SHOP DRAWINGS FOR: JOB NAME

1.25.21

STOREFRONT DETAILS

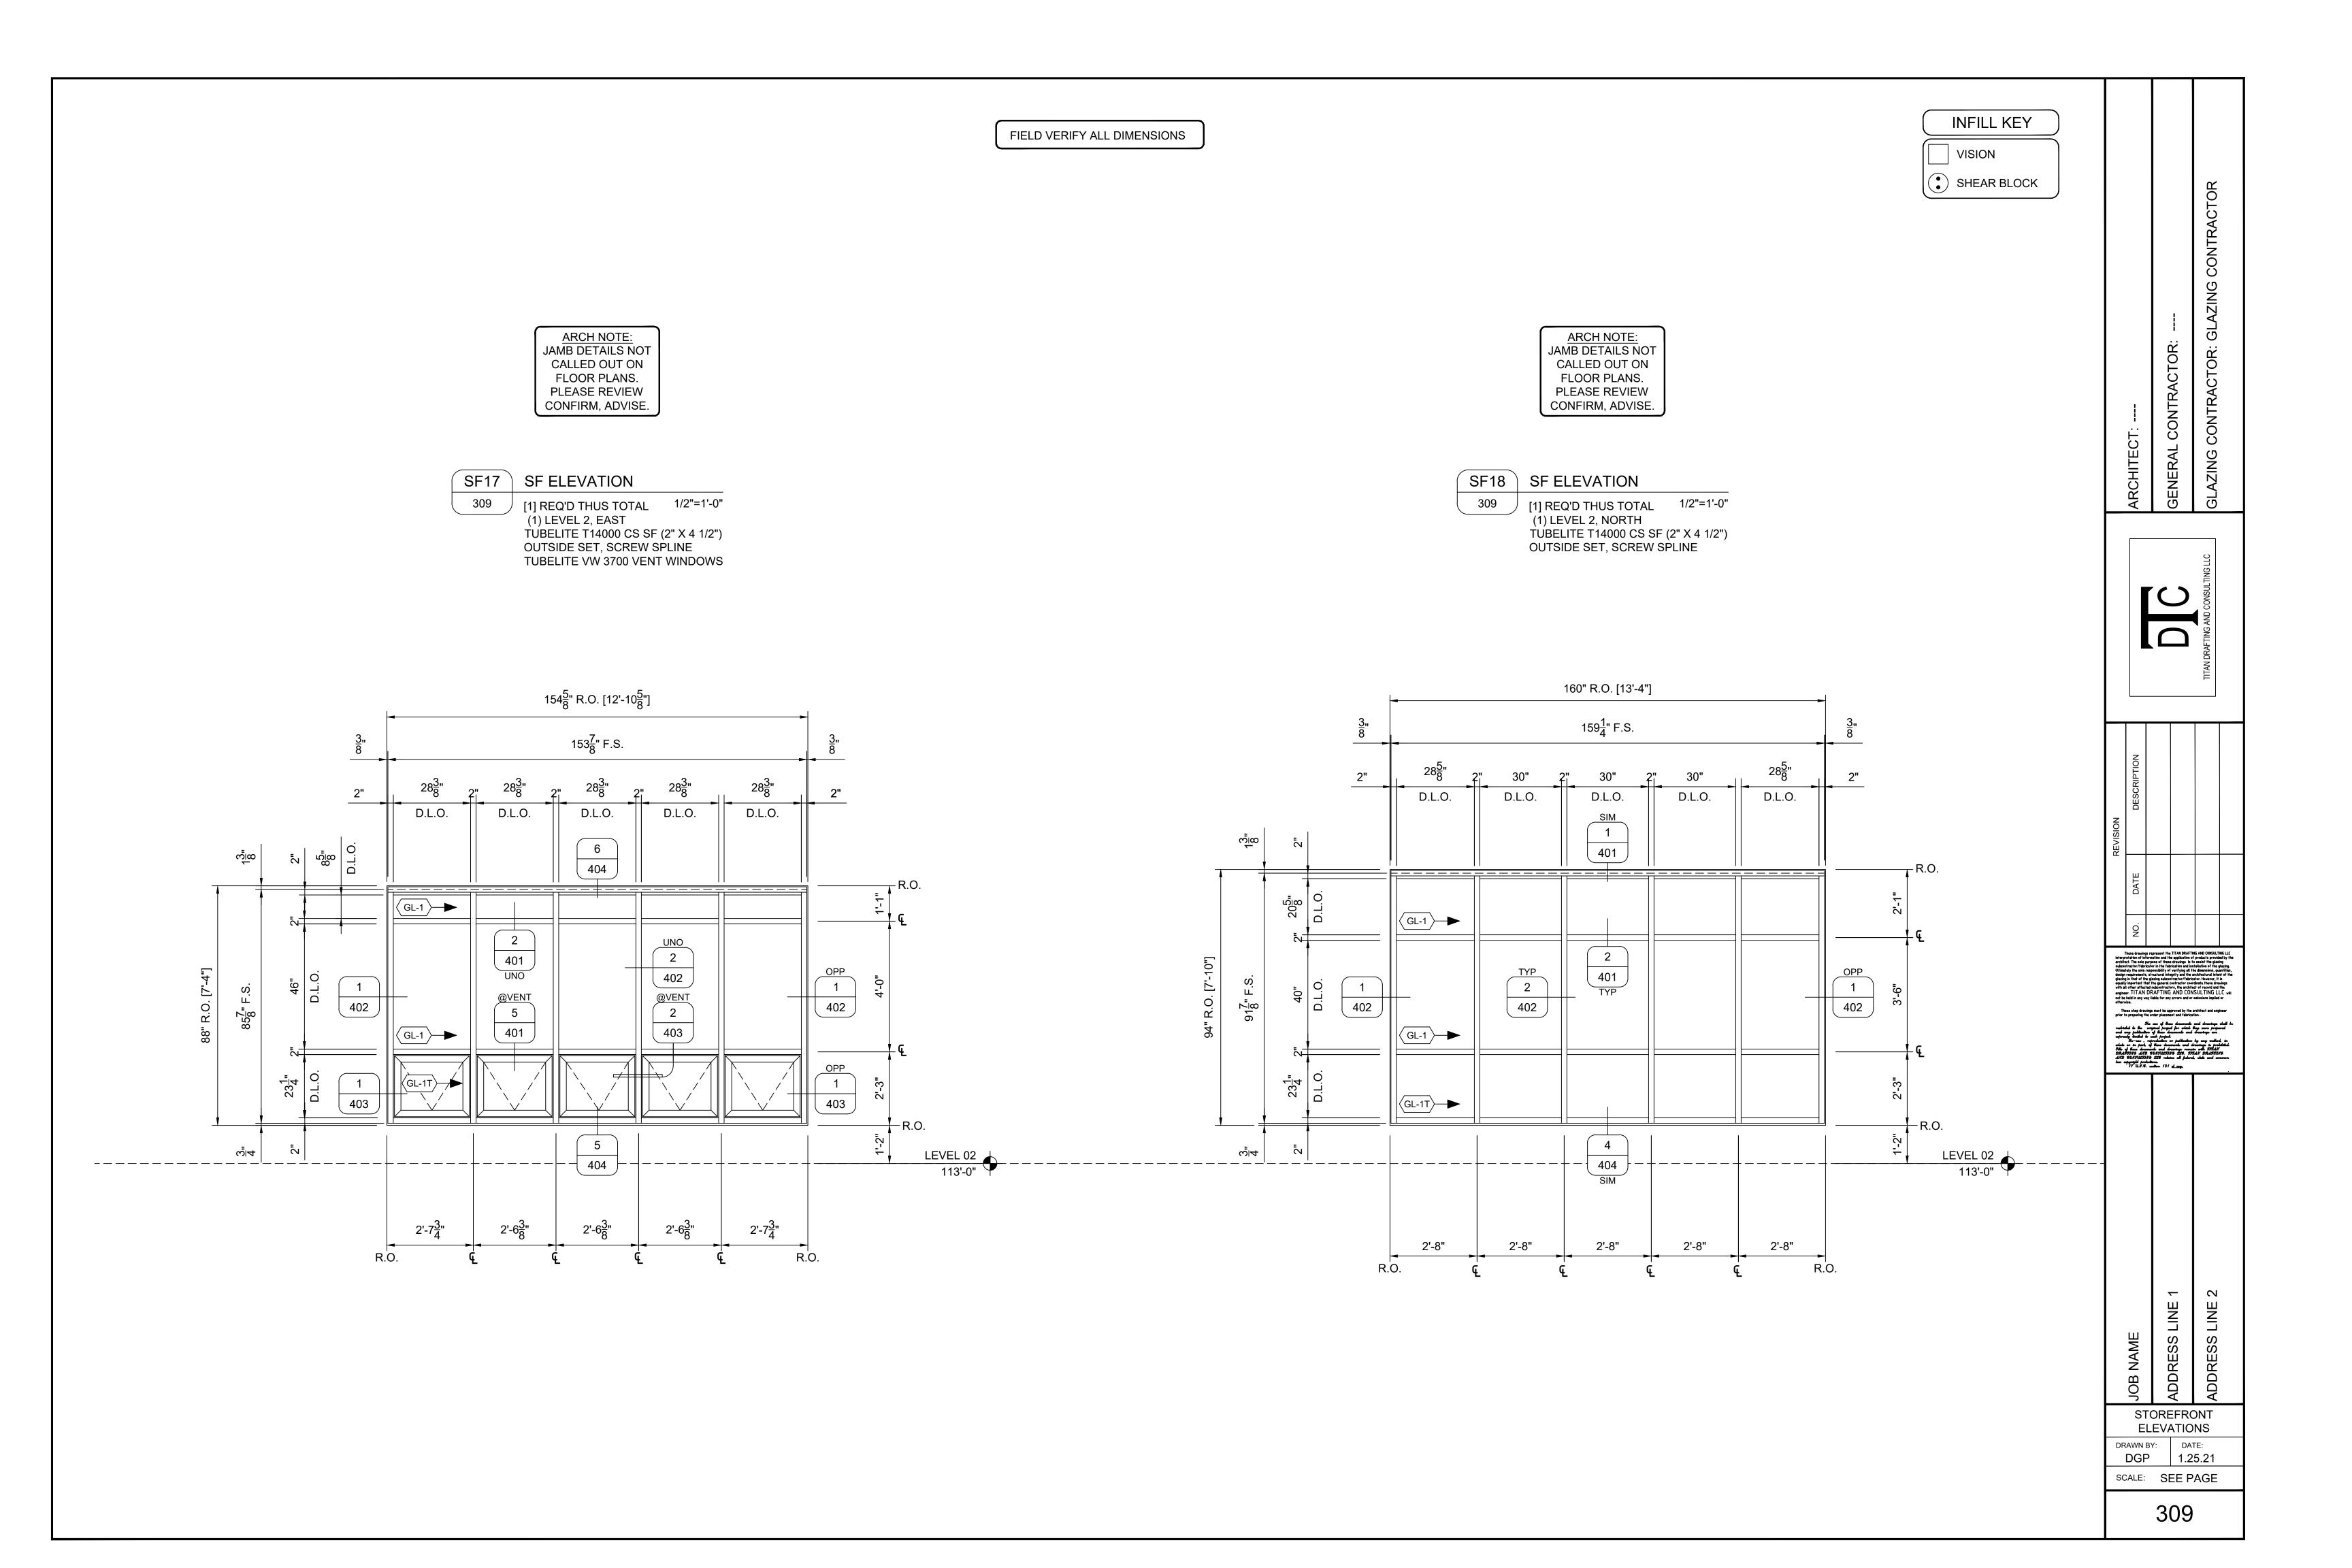
INFILL KEY FIELD VERIFY ALL DIMENSIONS VISION SHEAR BLOCK ARCH NOTE: DETAILS NOT ARCH NOTE: DETAILS NOT CALLED OUT ON FLOOR PLANS. CALLED OUT ON PLEASE REVIEW FLOOR PLANS. CONFIRM, ADVISE. PLEASE REVIEW CONFIRM, ADVISE. SF19 SF ELEVATION [3] REQ'D THUS TOTAL 1/2"=1'-0" SF20 SF ELEVATION (1) LEVEL 3, NORTH (1) LEVEL 4, NORTH 1/2"=1'-0" [1] REQ'D THUS TOTAL (1) LEVEL 5, NORTH (1) LEVEL 1, EAST TUBELITE T14000 CS SF (2" X 4 1/2") TUBELITE T14000 CS SF (2" X 4 1/2") OUTSIDE SET, SCREW SPLINE OUTSIDE SET, SCREW SPLINE TUBELITE VW 3700 VENT WINDOWS TUBELITE STD MED STILE DOORS,LHR-OUTSWING 64" R.O. [5'-4"] 54" R.O. [4'-6"] 63<mark>1</mark>" F.S. 53<mark>1</mark>" F.S. D.L.O. D.L.O. D.L.O. 3 4 402 401 403 401 GL-1 D 125 | ₁ | (GL-1) Σ₁Ω (2). 401 401 $106\frac{5}{8}$ F.S. (DOOR FRAME) 404 94" R.O. [7'-10"] UNO $91\frac{7}{8}$ " F.S. 402 402 402 403 403 403 401 403 403 GL-1T 100'-0" VARIES 404 SEE F.P. 2 ହ୍<u>ଜ</u>ା4 401 2'-8" R.O. D.O. 135 HDWR SET: 01 ADDRESS LINE 1 STOREFRONT **ELEVATIONS** DATE: DRAWN BY: DGP 1.25.21 SCALE: SEE PAGE 310

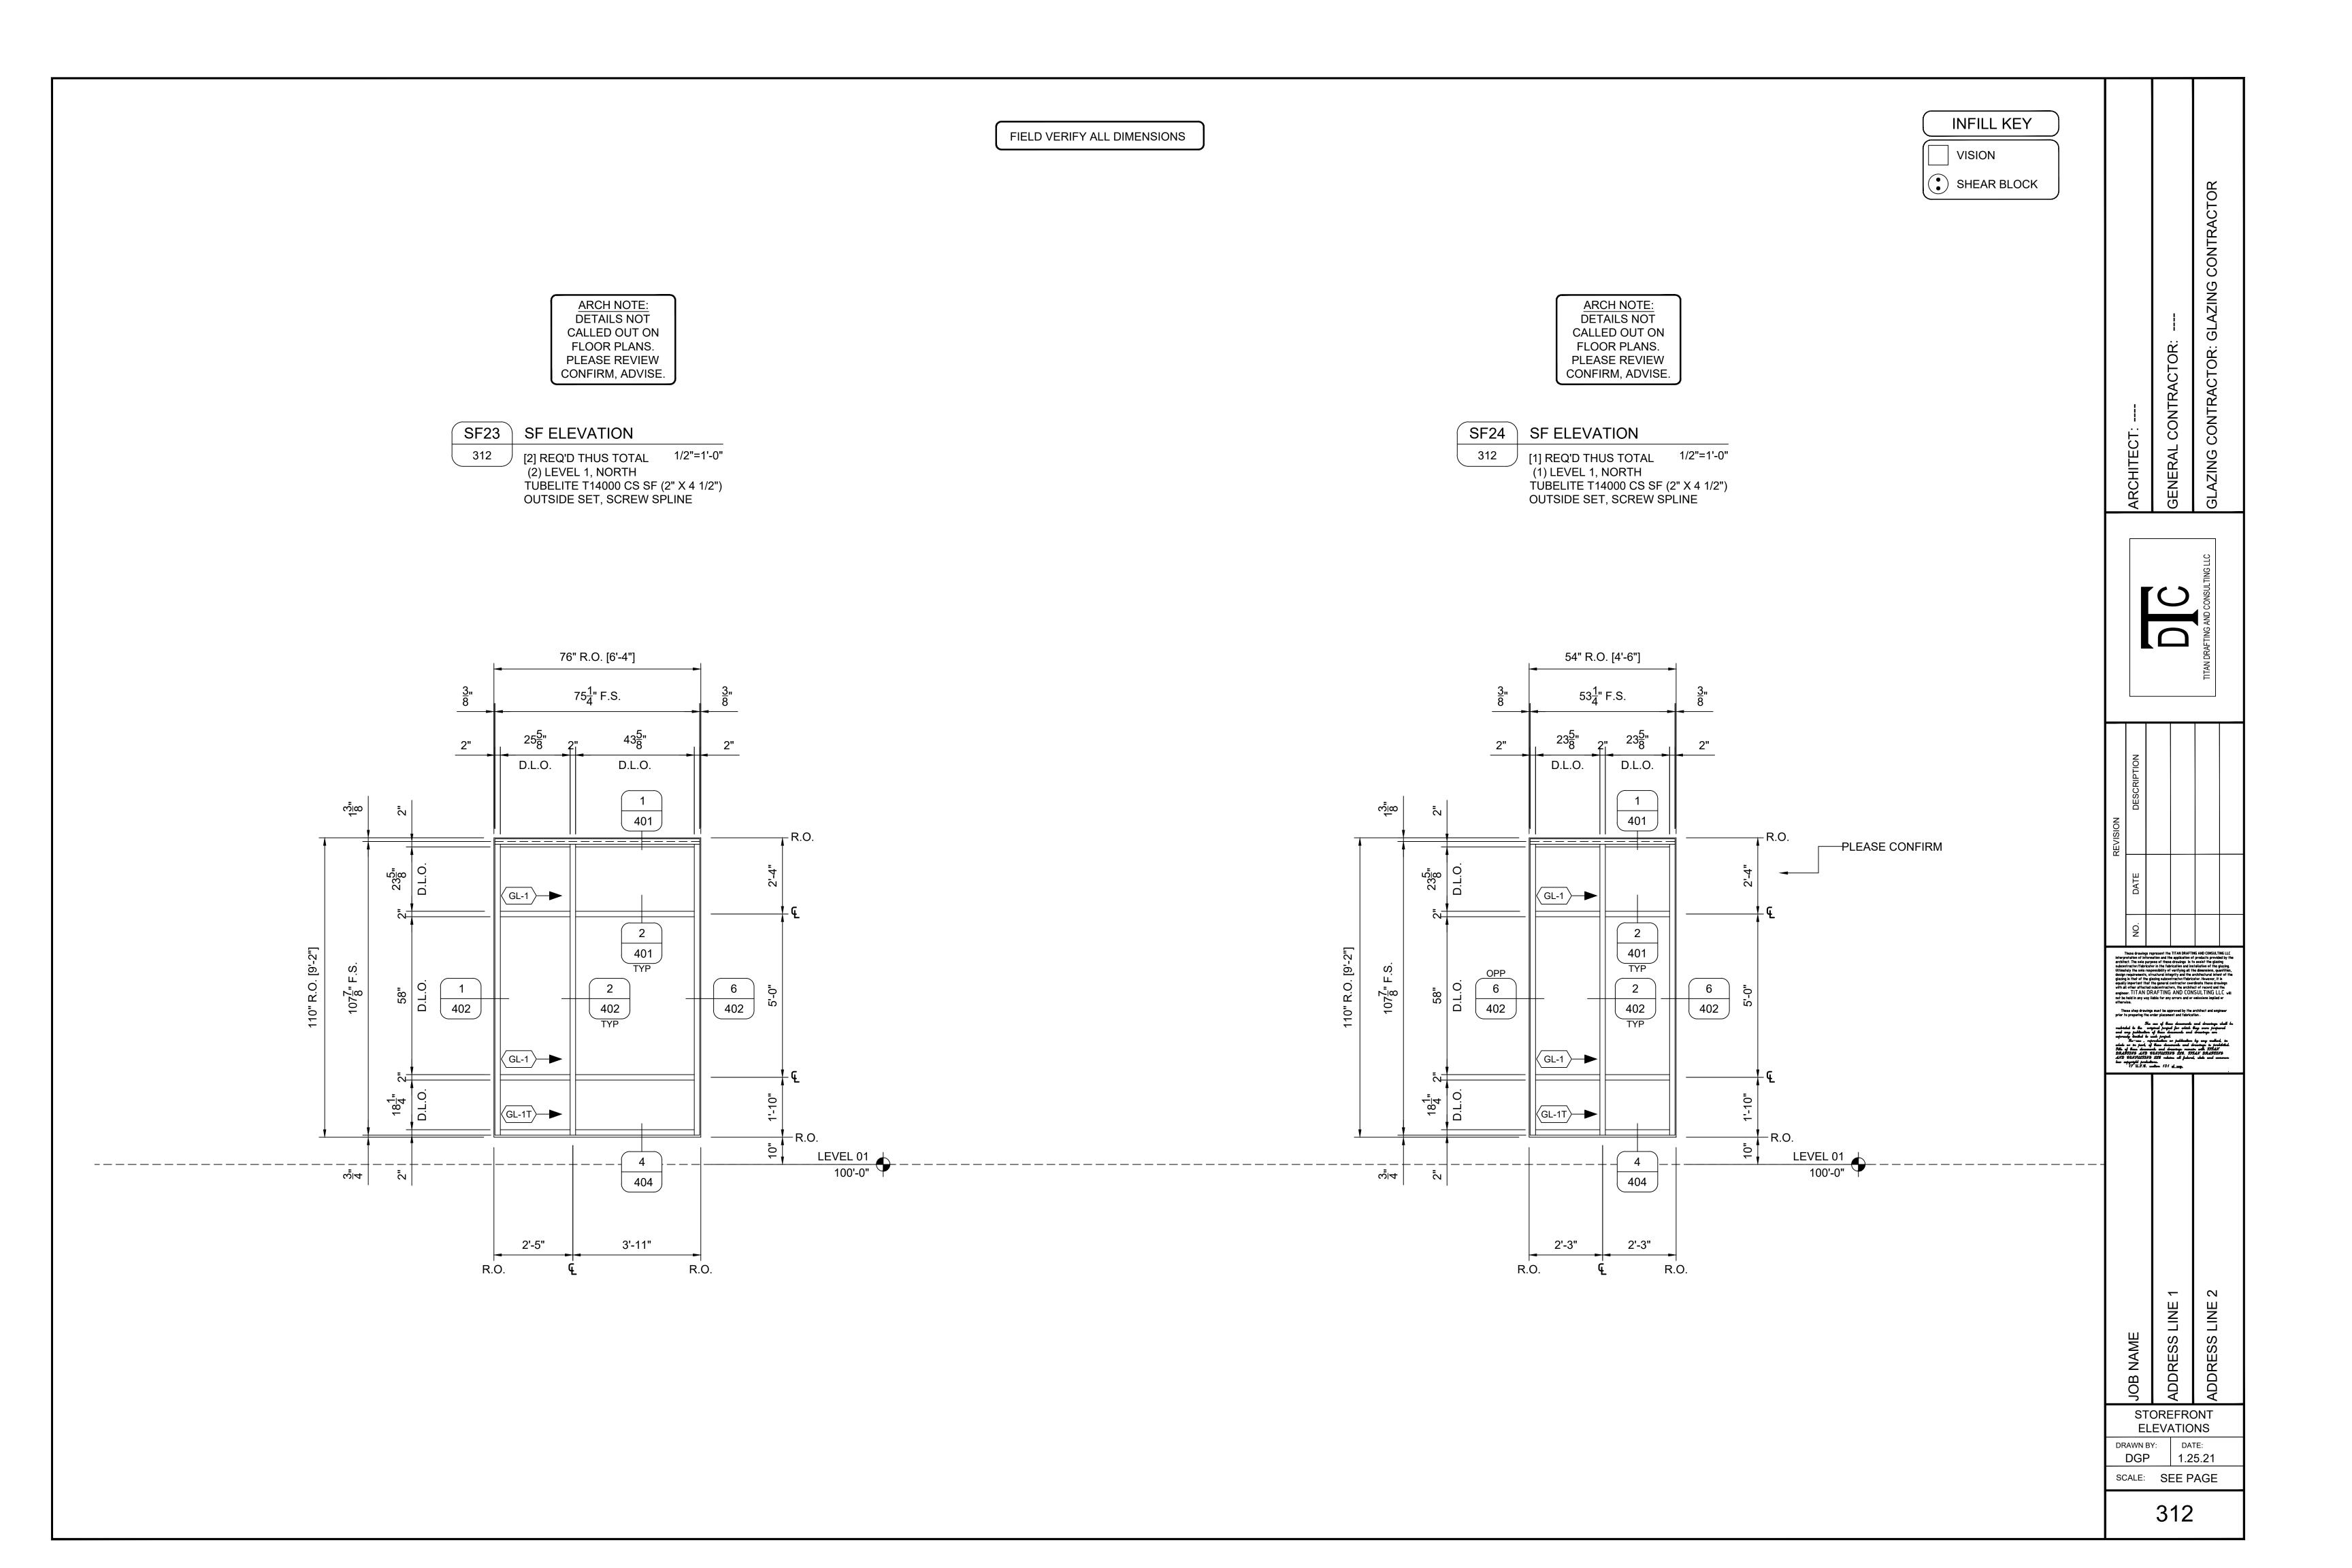
INFILL KEY FIELD VERIFY ALL DIMENSIONS VISION SHEAR BLOCK ARCH NOTE: ARCH NOTE: DETAILS NOT CALLED OUT ON DETAILS NOT FLOOR PLANS. CALLED OUT ON PLEASE REVIEW FLOOR PLANS. CONFIRM, ADVISE. PLEASE REVIEW CONFIRM, ADVISE. SF25 SF ELEVATION [4] REQ'D THUS TOTAL 1/2"=1'-0" SF ELEVATION (1) LEVEL 2, NORTH (1) LEVEL 3, NORTH 1/2"=1'-0" [1] REQ'D THUS TOTAL (1) LEVEL 4, NORTH (1) LEVEL 1, EAST (1) LEVEL 5, NORTH TUBELITE T14000 CS SF (2" X 4 1/2") TUBELITE T14000 CS SF (2" X 4 1/2") OUTSIDE SET, SCREW SPLINE OUTSIDE SET, SCREW SPLINE TUBELITE STD MED STILE DOORS,LHR-OUTSWING 52" R.O. [4'-4"] 32<u>1</u>" F.S. D.L.O. D.L.O. D.L.O. 3 <u>ω</u>[ω 402 403 401 401 GL-1 404 $106\frac{5}{8}$ " F.S. (DOOR FRAME) 401 94" R.O. [7'-10"] UNO $91\frac{7}{8}$ " F.S. 108" R.O. [9'-0"] 402 4 403 403 The way of these documents and drawings shall be restricted to the original people for which they were prepared and any publication of these documents and drawings are expressed from the to such people control of the such publication by any method, in what on its party of these documents and drawings to probability. The of these documents and drawings to probability. The of these documents and drawings was to probability. The original of the observations of the original state of the original state. The original state of the original state and communications of the original probabilities.

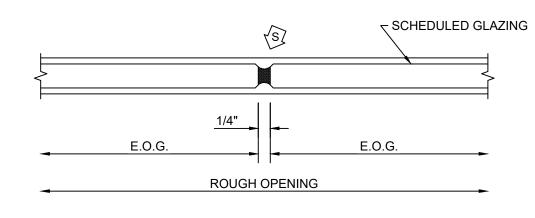
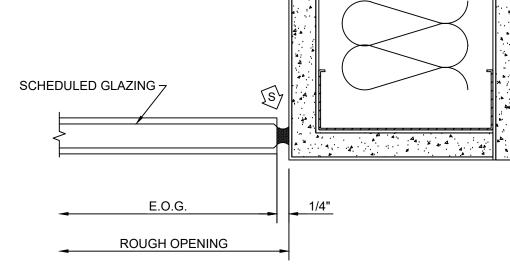
ARCHITECT NOTE:
DETAIL NOT PROVIDED PLEASE
REVIEW, CONFIRM, ADVISE.

ARCHITECT NOTE:
DETAIL NOT PROVIDED PLEASE
REVIEW, CONFIRM, ADVISE.
